ADDENDUM NO. 03

Franklin Central High School Addition & Renovations
6215 S. Franklin Rd.
Indianapolis, IN, 46259

ADDENDUM NO. 3 (THREE)

DATE: February 10, 2023
PROJECT: Addition & Renovations to Franklin Central High School
OWNER: Franklin Township Community School Corporation
PROJECT NO.: 2022043.00

ADD3-SK1

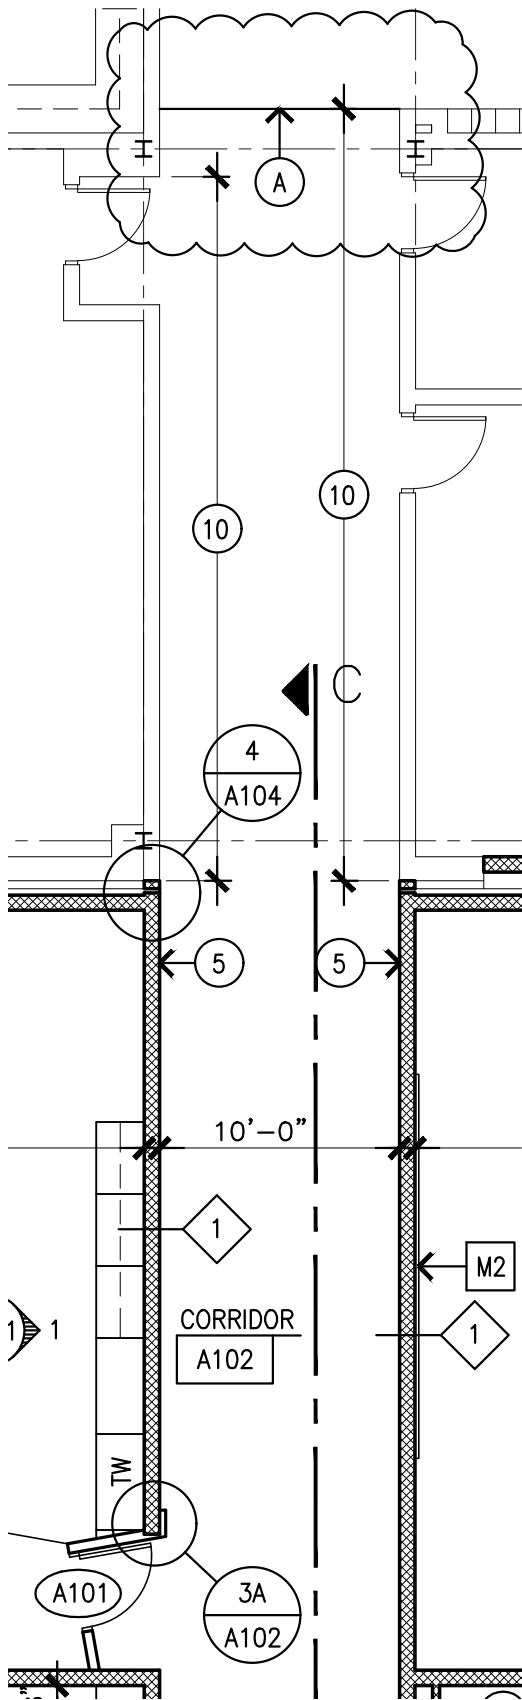
1. AT CORRIDOR A102, REMOVE EXISTING FLOORING & BASE & INSTALL NEW LVT FLOORING & RESILIENT BASE TO EXTENT INDICATED.

- (A) EXTENT OF EXISTING FLOORING DEMOLITION & NEW FLOORING & BASE INSTALLATION.

ADD3-SK2

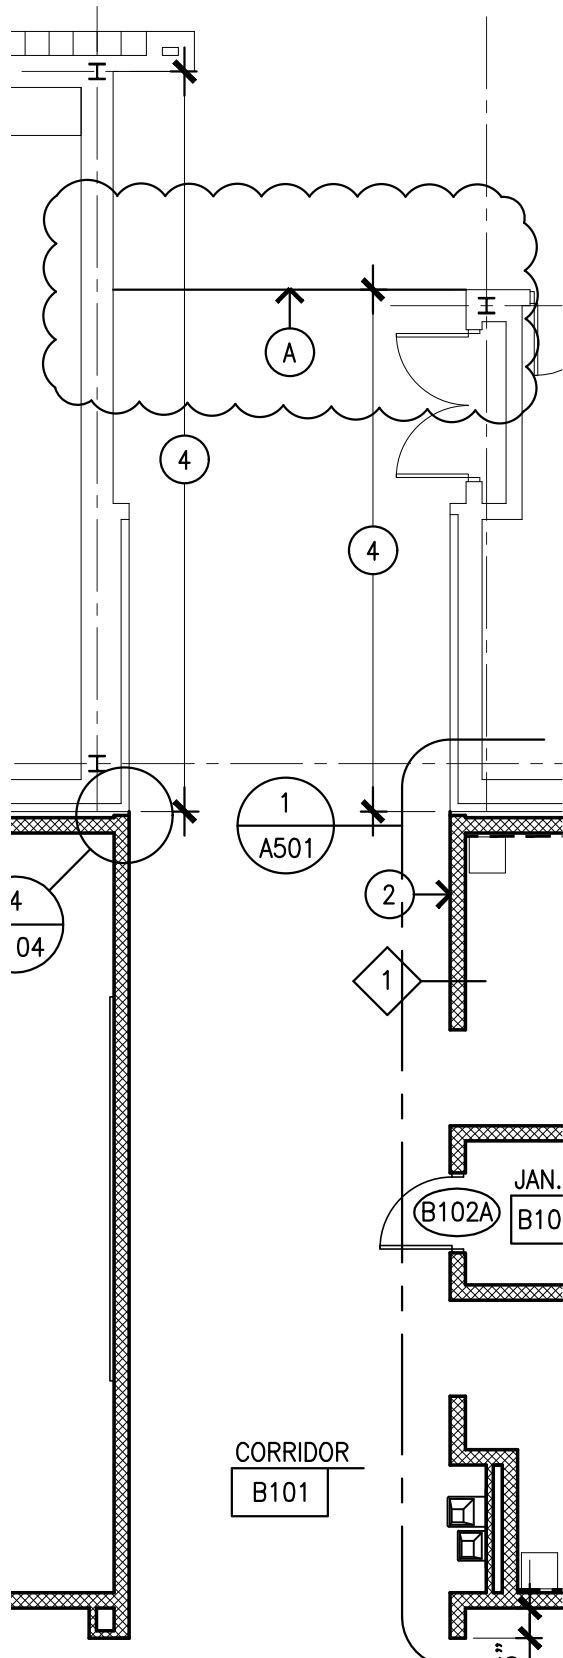
1. AT CORRIDOR B101, REMOVE EXISTING FLOORING & BASE & INSTALL NEW LVT FLOORING & RESILIENT BASE TO EXTENT INDICATED.

- (A) EXTENT OF EXISTING FLOORING DEMOLITION & NEW FLOORING & BASE INSTALLATION.

ADD3-SK3

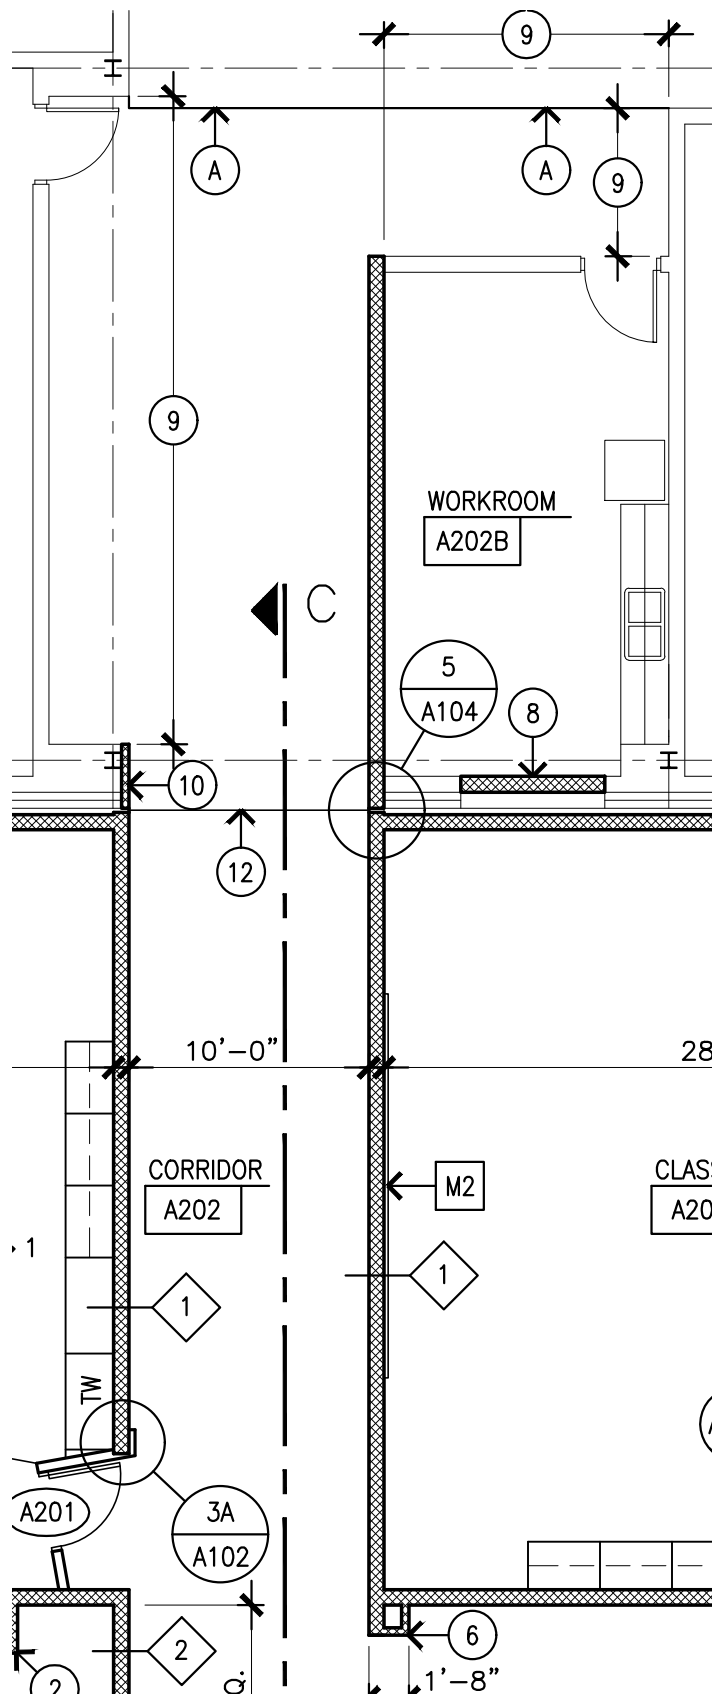
1. AT CORRIDOR A202, REMOVE EXISTING FLOORING & BASE & INSTALL NEW LVT FLOORING & RESILIENT BASE TO EXTENT INDICATED.

- (A) EXTENT OF EXISTING FLOORING DEMOLITION & NEW FLOORING & BASE INSTALLATION.

ADD3-SK4

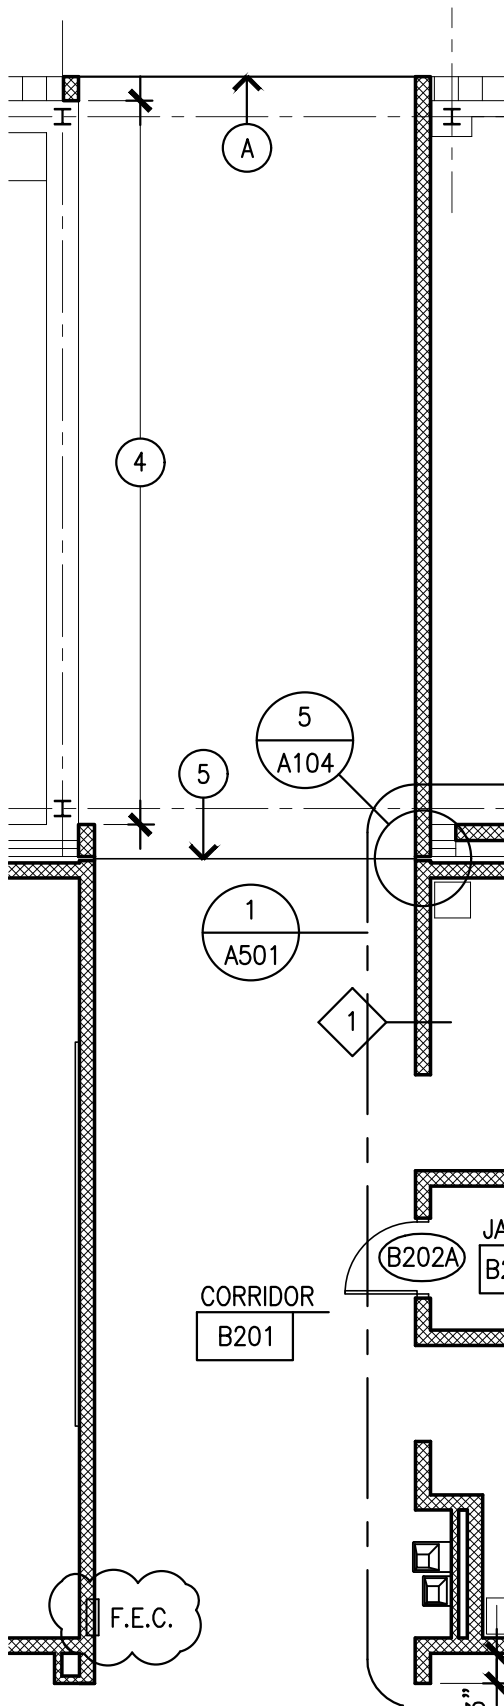
- (A) INDICATES EXTENT OF NEW LVT FLOORING & RESILIENT BASE INSTALLATION IN CORRIDOR B102.
